NOTICE OF PROJECT CHANGE

EEA # 14235

Brayton Point Station Cooling Tower Project

March 31, 2010

| Attachment B Most-Recently Reviewed Proposed Build Condition | |

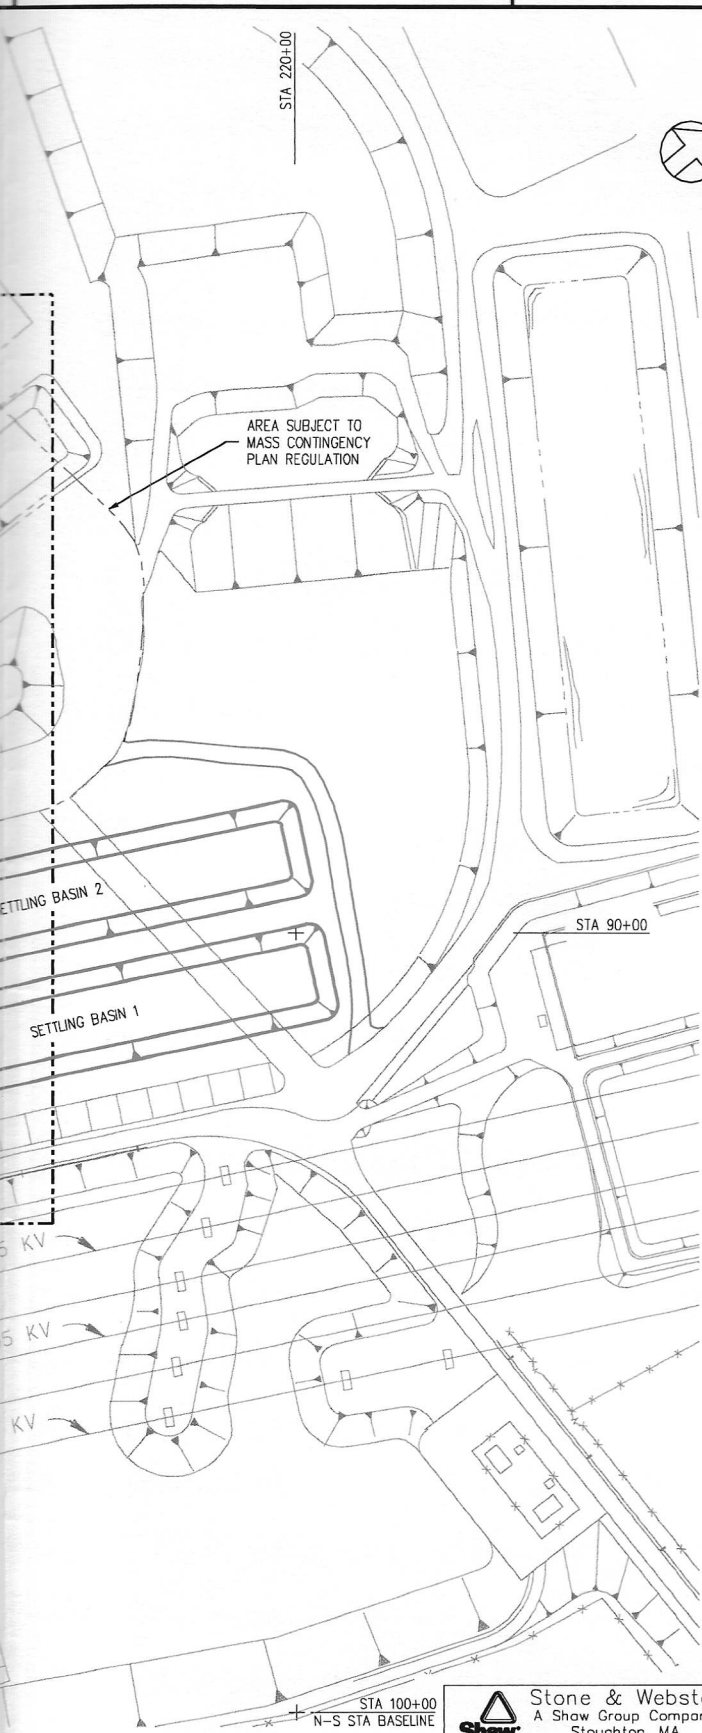
The material changes involve updates to the ancillary facilities to reflect final design. The ENF described ancillary facilities, including a service building, a bulk chemical storage building, a new cooling water pump house, piping, and modifications to the existing water control structures.

The final design construction details include additional dredge at the head of the existing discharge channel (for proper installation of the cooling water pump house and water control structure), some fill at the head of the existing discharge channel (to avoid stagnant areas), a pipe bridge over the existing discharge channel (to allow cooling tower blowdown with minimized pipe friction energy losses), and an additional building (blowdown building, approximately 80 feet by 40 feet, to allow proper mixing and monitoring of cooling tower water discharge). A revised site layout figure is attached.

| Certificate Language | Dominion Comments |
|--|--|
| Approximately 19,000 square feet of Land Under the Ocean, 300 linear feet of Coastal Bank, Designated Port Area, and Riverfront Area will be impacted. | Impacts remain limited to modification of existing licensed (Chapter 91 and Army Corps of Engineers) discharge structures on site. Based on final construction details, approximately 35,900 square feet of Land Under the Ocean, 1,067 linear feet of Coastal Bank, Designated Port Area, and Riverfront Area will be impacted. |
